General Bid Bulletin No. 32
01 October 2021

**THE MALOLOS-CLARK RAILWAY PROJECT AND THE NORTH-SOUTH RAILWAY
PROJECT SOUTH LINE COMMUTER PACKAGE CP NS-01: PROCUREMENT OF
ELECTRICAL AND MECHANICAL SYSTEMS AND TRACK WORKS (IFB No: 21-040-3)**

This General Bid Bulletin is issued to amend/clarify certain provisions in the Bidding Documents for the above-mentioned Project. Please refer to the attached Annexes of this General Bid Bulletin for details:

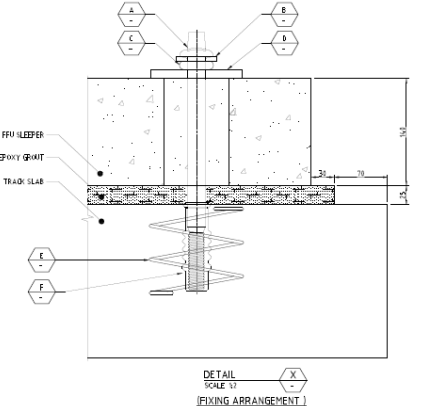
Item No.	Volume Section No. Page No. Clause No. / Title Reference Text	Clarification Request	Proposed Revised Text (if any)	Response
	side surface of the sleeper. The coefficient of elasticity of the material shall be about 250-300MN/m. The elastic materials at the sleeper bottom, end and side surface is one set and can be considered as Boot or Anti Vibration Sleeper box following the requirement stated in ERT 1.14.1. The contractor shall submit the detailed design subject to Engineers review and approval.	Concrete. Hence, we understand that bidder need not to provide separate Boot or Anti Vibration Sleeper Box. Kindly clarify the same, as this may lead to significant cost impact.		
24	Part -2 Section VI, ERT-32 5 of 84, 1.14.1, 4) The elastic material shall be adhered on the bottom surface of the sleeper beneath the rail position. The coefficient of elasticity shall be 25-30MN/m. 5) Deformable clearance material shall be attached to the bottom surface of the sleeper to avoid adhesion between the sleeper and	From the referred Clauses and Drawings, we understand that the Elastic Material shall be attached to the Sleeper bottom, end surface and side surfaced at the factory itself. Some of our suppliers, who have experience of supplying elastic material in various projects with similar Track in Japan and outside Japan are expressing concerns that the chemical materials used in the Elastic mats and Deformable clearance material are prohibited in Philippines and refusing to supply the same material.		It is the contractor's obligation to interface with outside authorities as stated in ERT 1.4.10. In case that the material proposed by the contractor are prohibited to enter the Philippines, the contractor shall propose equivalent material following the requirement of this contract and subject to Engineer's review and approval.

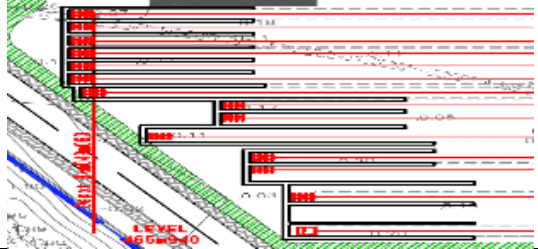
Item No.	Volume Section No. Page No. Clause No. / Title Reference Text	Clarification Request	Proposed Revised Text (if any)	Response
	<p>install a plinth into which walkway fixings can be attached. The exception to this is the CP05 area where drilling to the deck is permitted subject to the precautions regarding damage to the civil works are approved and implemented.</p>			
31	<p>Part -2 Section VI & GBB No.22, ERT-50 & 133/219, 1.23 (25), 25) For the at grade areas concrete footings shall be provided for the walkway. 25) On the viaduct sections drilling into the deck shall not be permitted and the contractor shall design and install a plinth into which walkway fixings can be attached. The exception to this is the CP05 area where drilling to the deck is permitted subject to the precautions</p>	<p>We understand from the referred clause in GBB-22 that on the Viaduct sections, if the contractor is not permitted to drill into the deck of the viaduct to fix the supports of walkway to the Viaduct, the civil contractor provides bolt kind of system to provide anchorage between walkway and the viaduct. Kindly confirm.</p>		<p>The Bidder's understanding is incorrect. The Contractor shall provide all fixings to the viaduct deck.</p>

DATE	MAY 2019
SCALE	AS SHOWN IN A1
SHEET No.	
DRG No.	MCRP-DWG-GEN-TK-0117
DRG S.	REV 04

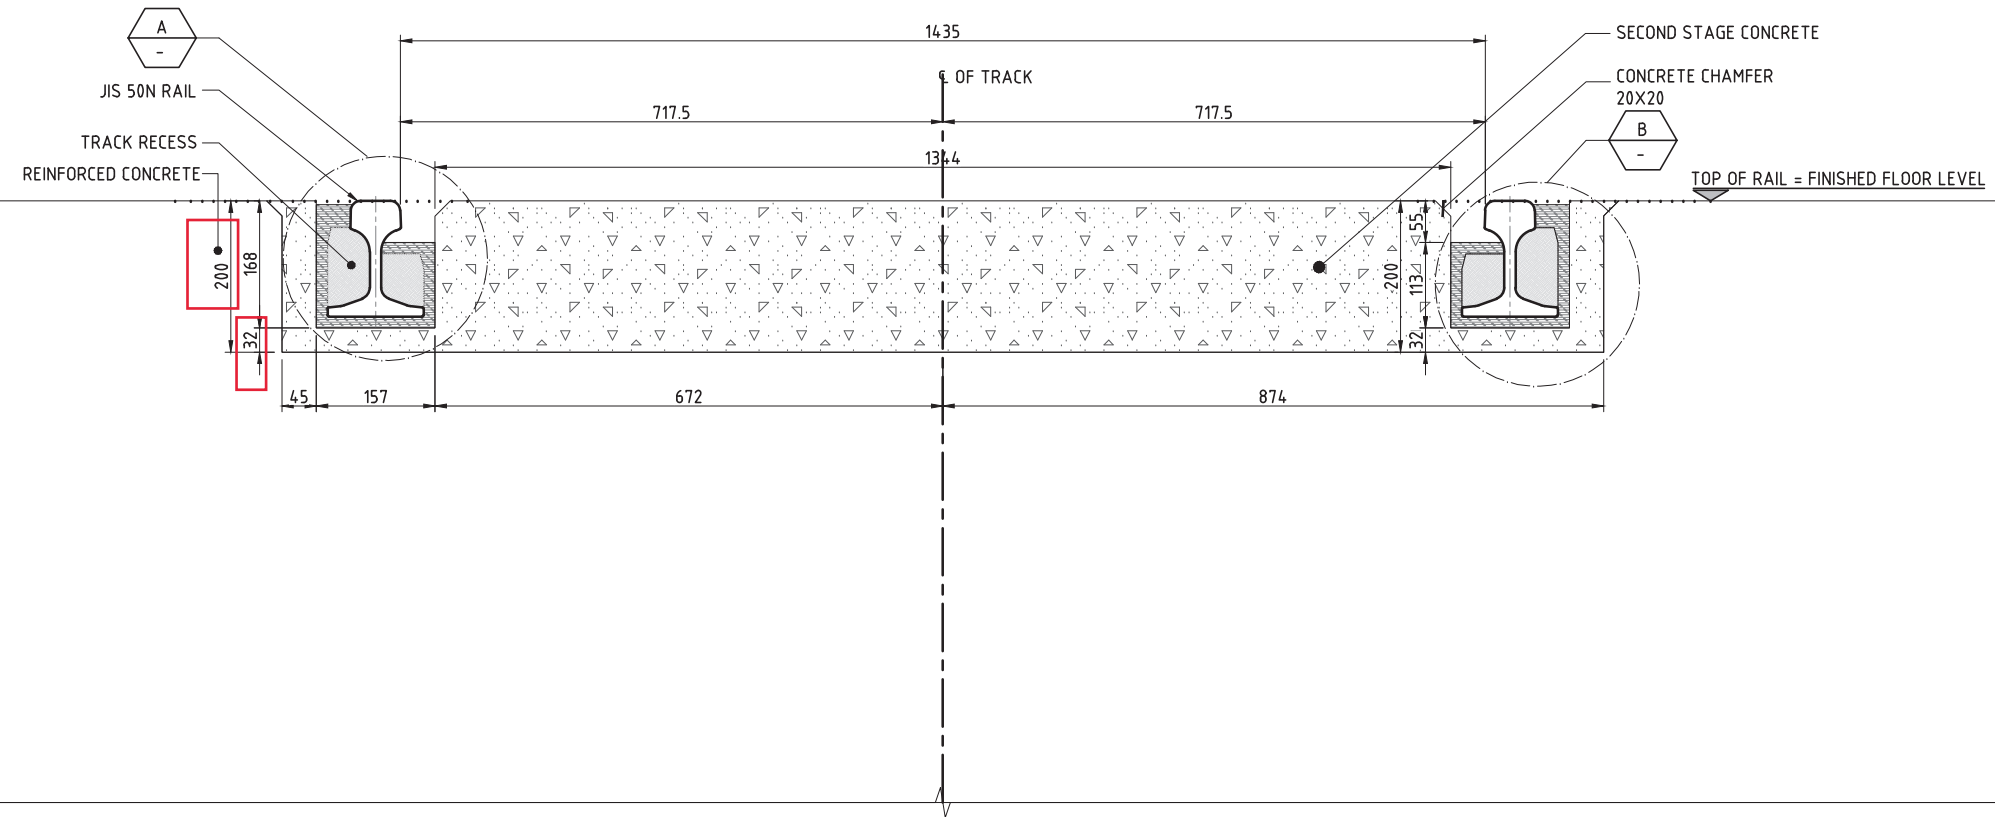
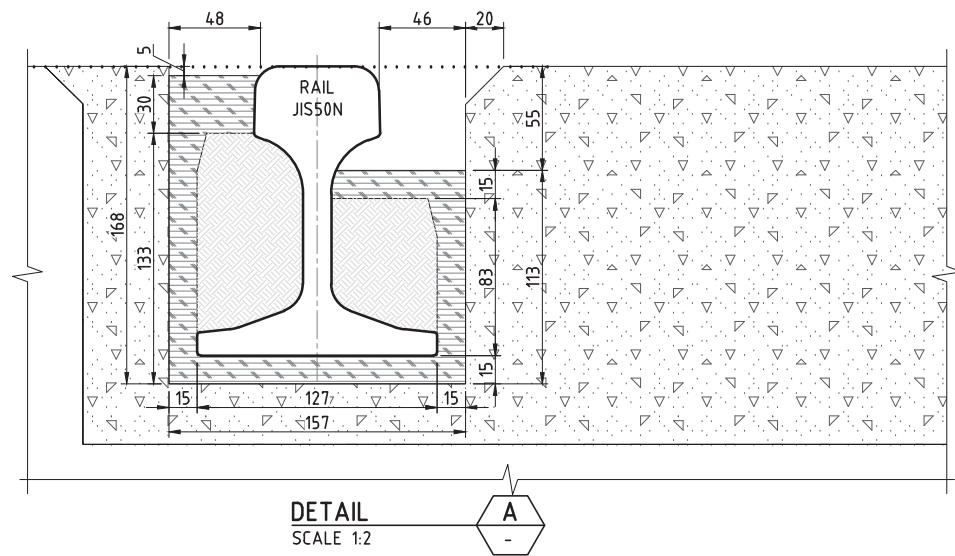
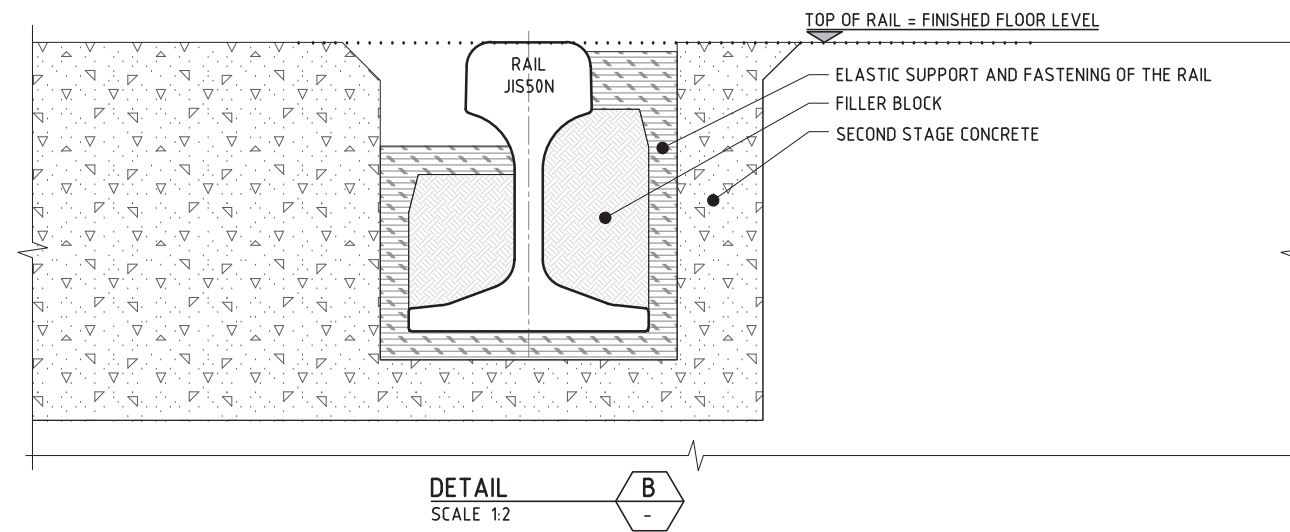
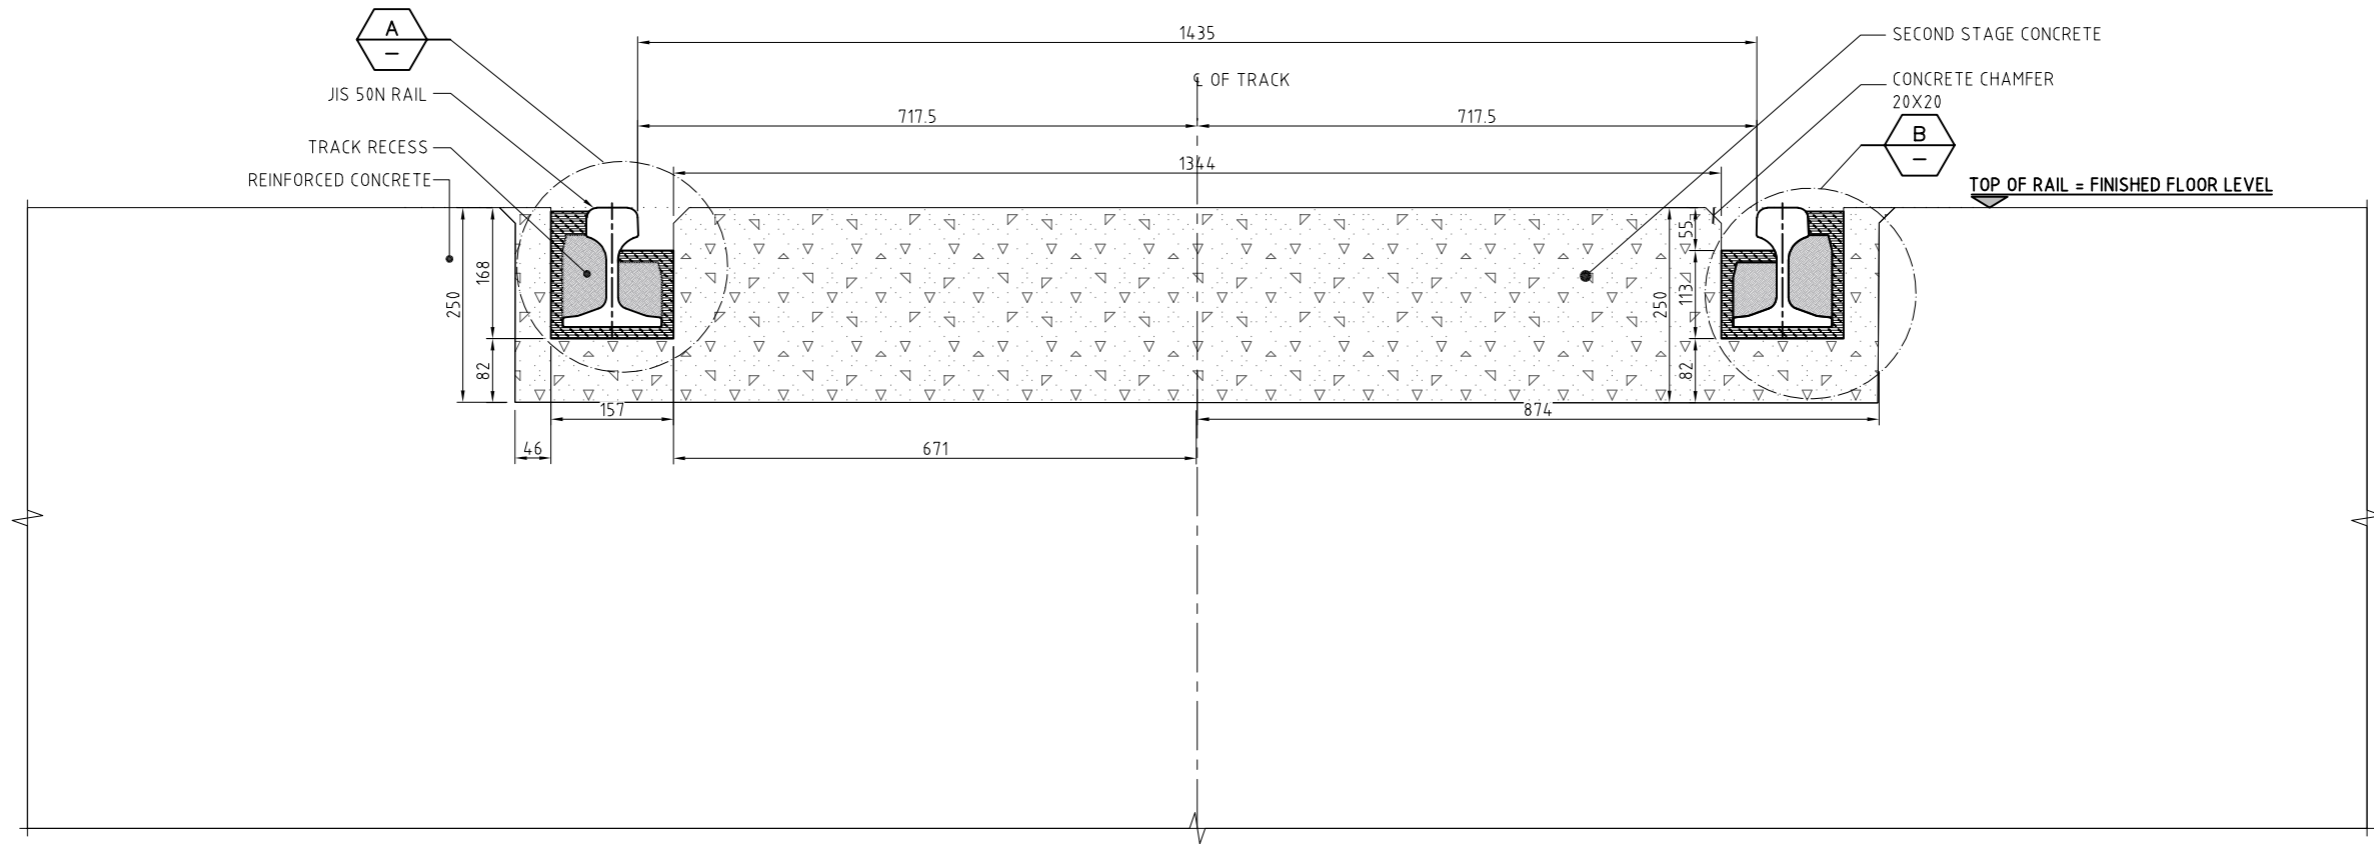
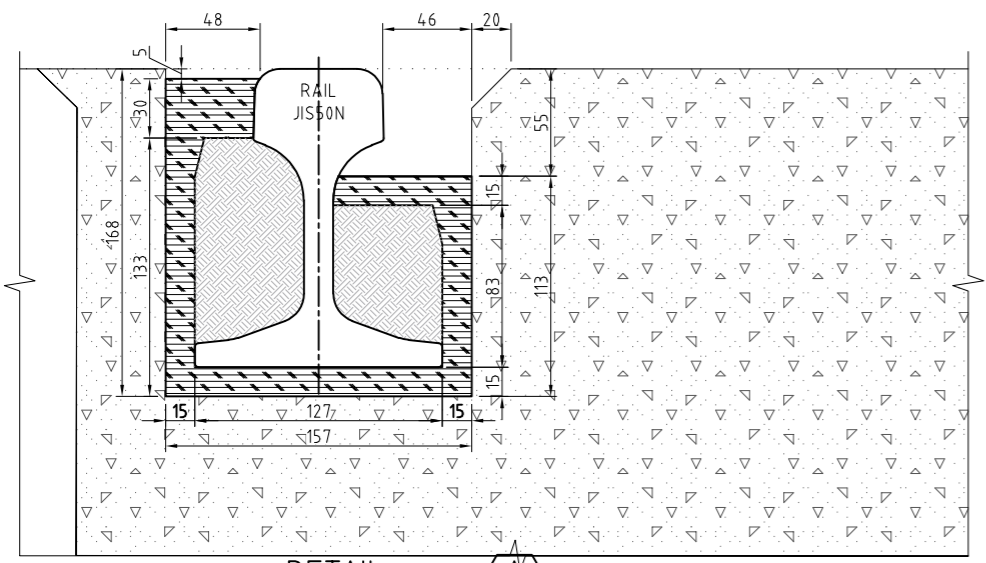
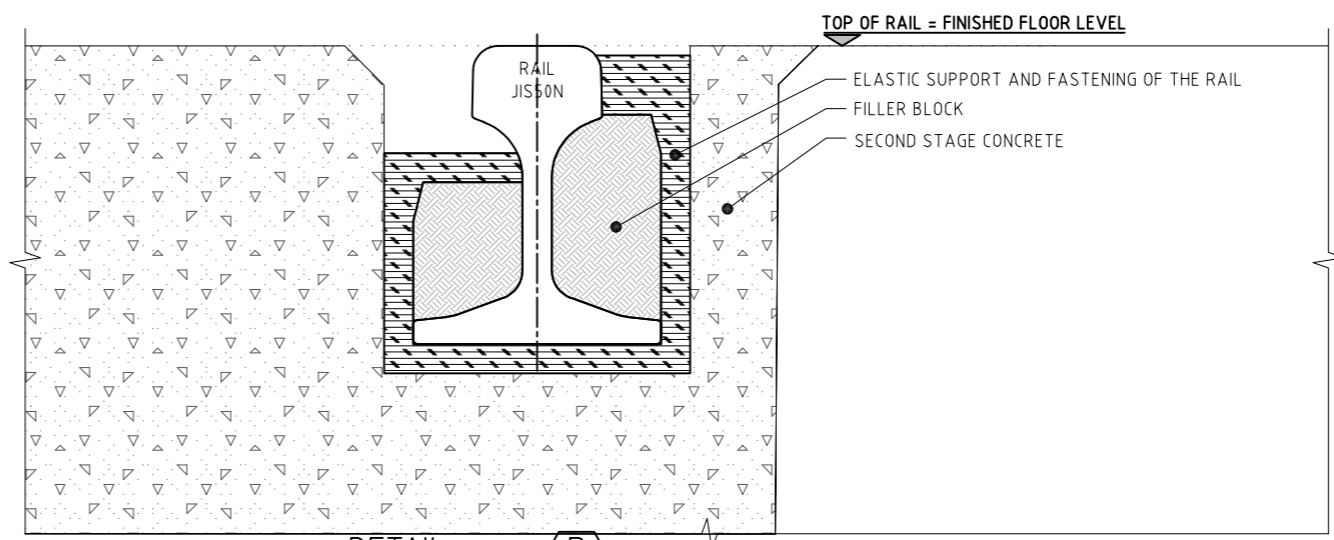
Item No.	Volume Section No. Page No. Clause No. / Title Reference Text	Clarification Request	Proposed Revised Text (if any)	Response
	regarding damage to the civil works are approved and implemented.			
32	Part -2 Section VI, ERT-50, 1.24, Access Platform and Stairs 10) Length of the platform should facilitate easy entry and exit into the Trainset for 2 Car length	We understand from the referred clause that the contractor shall supply and install Access Platform and Stairs in the depot stabling areas. The access platforms shall be positioned to allow access to the nearest passenger train doors. Hence, we understand that the bidder need to provide 2 Access platforms with stairs on each side of track to facilitate easy entry and exit into the trainset for 2 car length and the contractor need not to provide a continuous platform for the entire length of train. Kindly confirm.		The access platform shall be constructed in "U-Shape" as stated in ERT 1.24 11), to allow the access on both sides of the train for 2 car length. The Bidder shall propose the detailed design and location of the stairs subject to Engineer's review and approval. Please refer to the drawing below for reference.

Volume III Part 2 – Employer’s Requirements d) Employer’s Drawings		
28	Volume III Part 2- Employers Requirements Drawings (a)	Drawing MCRP-DWG-GEN-TK-0206 REV. 03 has been revised to drawing MCRP-DWG-GEN-TK-0206 REV. 04
29	Volume III Part 2- Employers Requirements Drawings (a)	Drawing MCRP-DWG-GEN-TK-0117 REV. 03 has been revised to drawing MCRP-DWG-GEN-TK-0117 REV. 04
